Re: TDE Review
Comments from Review of Applicant Materials
Tilden Commons
538 US Route 20
File: 1229.010.001

Barton & Loguidice, D.P.C. (B&L) has completed a sixth-round technical review of revised materials submitted in support of the site plan and special use permit applications for the proposed Tilden Commons project located at 538 US Route 20 in the Town of New Lebanon, as proposed by Tilden Project LLC (Applicant). This review was conducted following B&L's prior comment letters dated August 13, 2025 (Comment Letter #1), September 23, 2025 (Comment Letter #2), December 17, 2026 (Comment Letter #3), and March 10, 2026 (Comment Letter #4), and April 14, 2026 (Comment Letter #5) and focuses on evaluating the Applicant's responses to outstanding comments, revisions to plans and reports, and supplemental materials submitted since the Planning Board's most recent review.

Sheet C100 – EXISTING CONDITIONS AND DEMOLITION PLAN

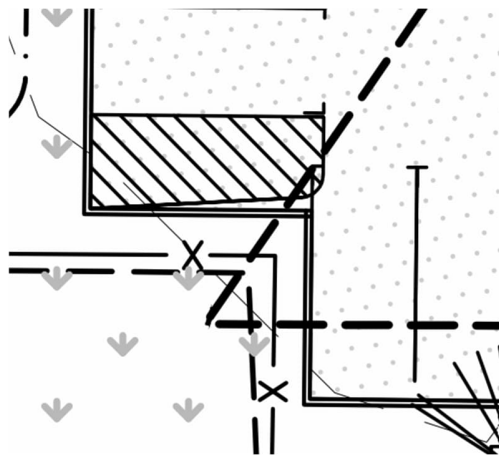
1. The erosion and sediment control measures are shown on this plan. Please make a separate erosion and sediment control plan.
2. Call out the existing well to remain and be protected.
3. Show and call out the limit of disturbance on this plan and on the erosion and sediment control plan.
4. Please show the construction entrance as 50' length and 12' width as shown in the erosion and sediment control details and add length and width dimensions.

5. Only show one construction entrance on the site off Tilden Road instead of U.S. Route 20.
6. Add silt fence around the topsoil stockpile area.
7. Silt fence shall be installed parallel to existing contours and should not be shown as being installed over the construction entrance. Also, ensure silt fence is within the limit of disturbance.
8. The landscaping plan was revised to remove the two trees to remain. Revise on this plan.
 - a. It appears that the existing shrubs along the property line of Pierre & Patricia Joseph are to remain. They will likely be disturbed during construction and shall be replaced.
